Re: Former Chevron Service Station No. 9-1026
3701 Broadway
Oakland, CA

Re: Addendum to Site Investigation
Former Chevron Service Station 9-1026
3701 Broadway
Oakland, California
Fuel Leak Case No. RO0000500

UPDATED FIGURE 4 - SOIL BORINGS LOCATIONS AND SOIL CONCENTRATIONS

FIGURE 4

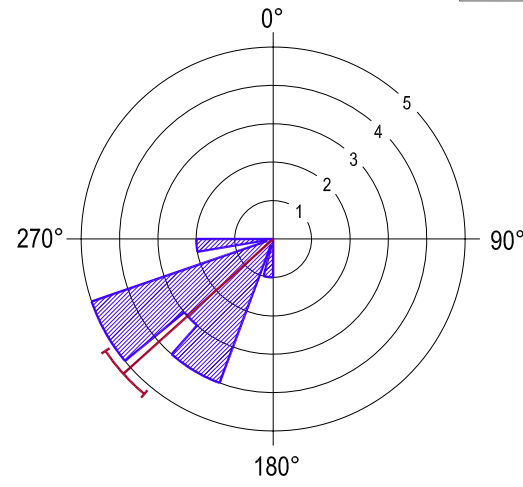
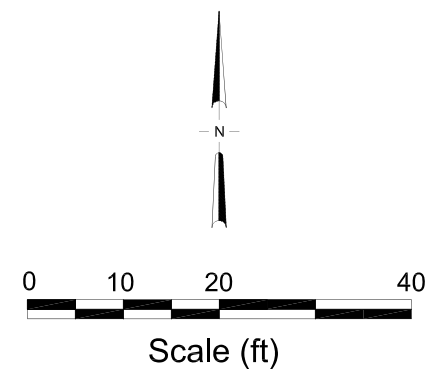
- Site Investigation and Remediation Report Section 3.2 states, "Cambria advanced 22 soil borings (CSB-1 through CSB-22). Table 1 presents analytical data for only 19 soil borings, no data presented for soil borings CSB-2, CSB-15 and CSB-21,
- Boring logs were completed for 18 soil borings, excluding soil borings CSB-1, CSB-2, CSB-15 and CSB-21,
- Figure 4 shows soil analytical data for 18 soil borings, excluding soil borings CSB-1, CSB-2, CSB-15 and CSB-21,
- Figure 5 which shows "sidewall" soil boring locations and contamination concentrations omitted soil analytical data for sample SWW-4,
- Figure 6 lists benzene concentrations for bottom soil samples EX-8-20, EX-9-20 and EX-10-20 in units of mg/kg, however, laboratory analytical data for benzene are presented in units of µg/kg and have not been converted correctly.

- Figure 4 excluded analytical data from borings CSB-2, CSB-15, and CSB-21 because soil samples were not collected in these borings due to refusal. Boring CSB-1 is the same as boring as SWE-4 and soil analytical data was included in the original report. Figure 4 was updated to include the incomplete borings and is included as Attachment B.
